REMARKS

Claims 1-39 are pending. By this Amendment, the drawings are revised pursuant to a Request for Approval of Drawing Corrections, the specification and claims 37 and 39 are amended. No new matter is added by any of these amendments.

APPENDIX

FIG. 6

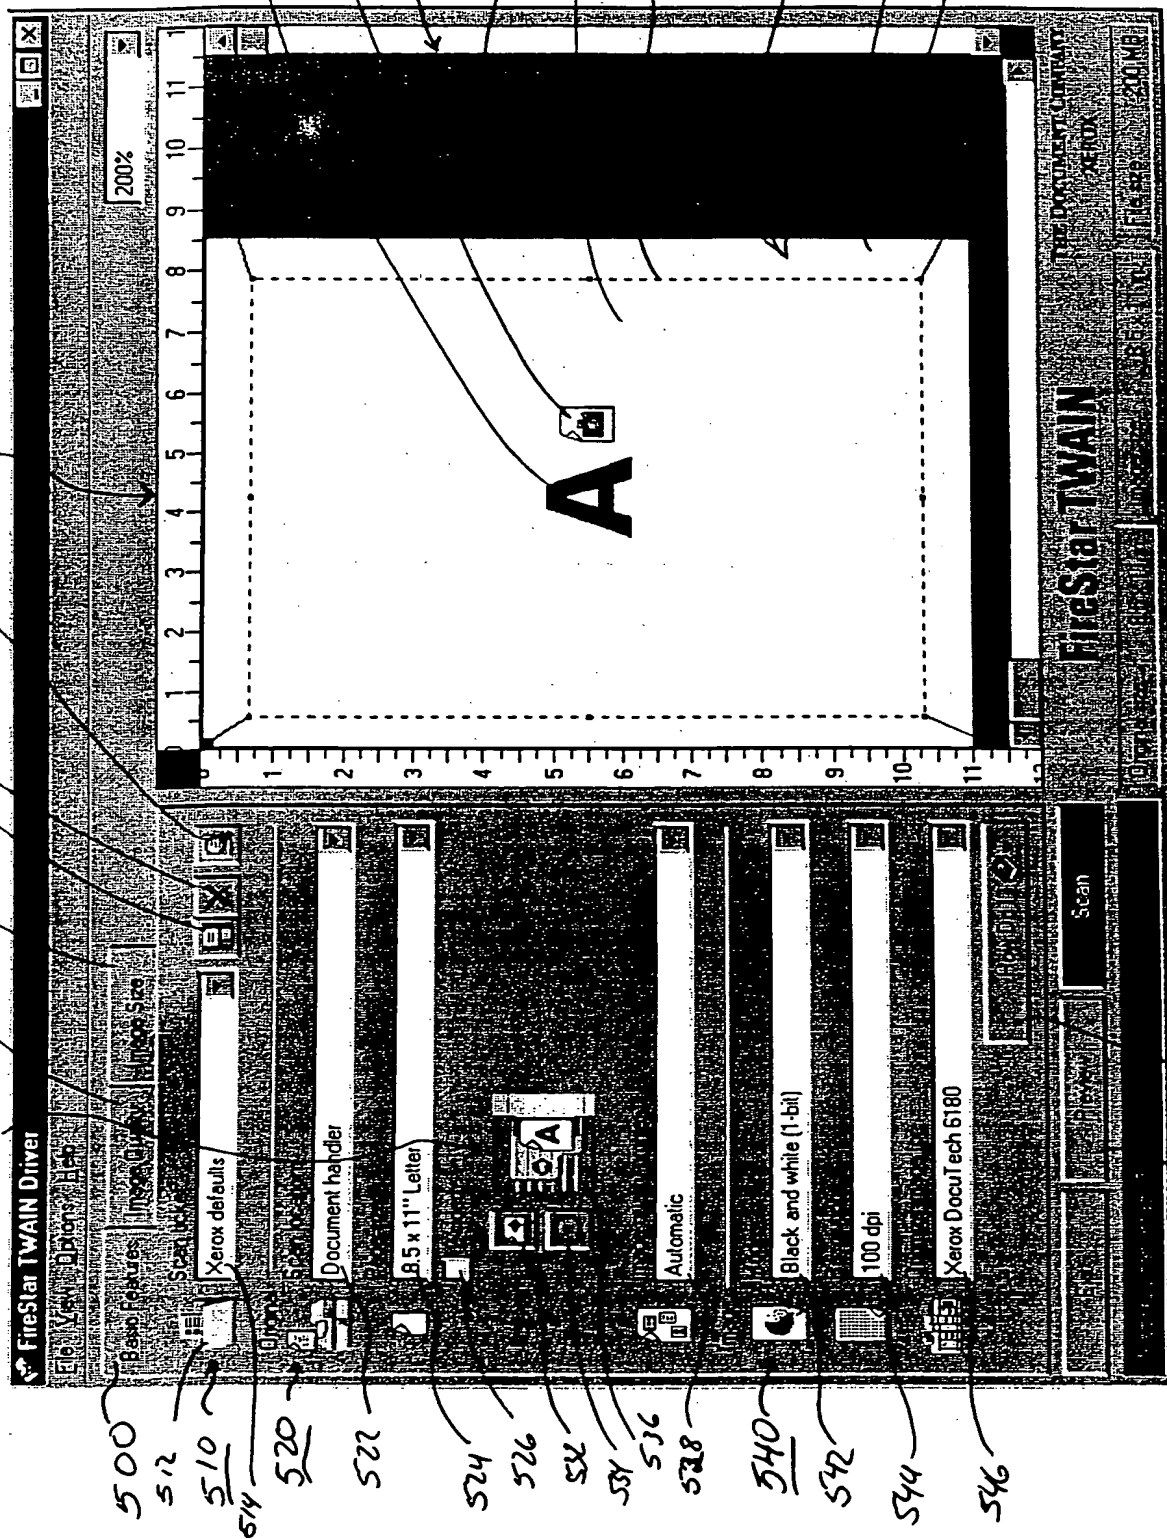
The Office Action and Notice of Draftsperson's Patent Drawing Review object to the drawings based on informalities. Figure 6 is revised pursuant to the attached Request for Approval of Drawing Corrections. Formal Drawings will be filed upon Notice of Allowance. Withdrawal of the objection to the drawings is respectfully requested.
